Access Compliance Report

Public Rights-of-Way

(Pedestrian Signals)

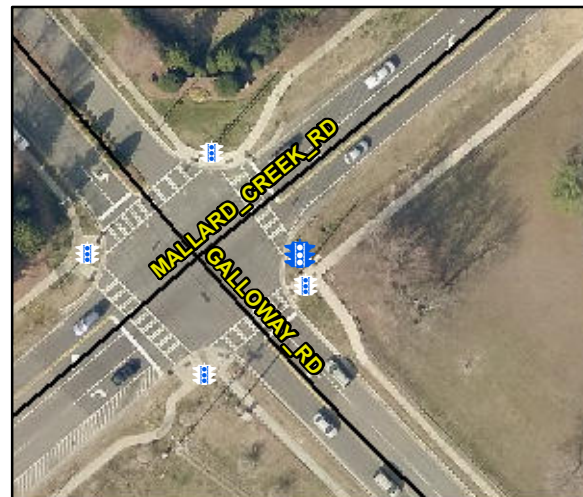
Intersection ID: N/A	Main Street:	Cross Street: N/A	Location: N/A
ADA ID: 5F800C1383BA	Signal Type: One Push Button-Non APS	Overall Compliance: No	Severity Score: BTN 1: N/A BTN 2: N/A No BTN: N/A
Codes/Mitigation Info/Possible Solution		Field Measurements/Component Compliance

PROW/ADA: R404.1, R404.7.3

Possible Solutions: Provide Push Button Extension. Provide Clear Space.
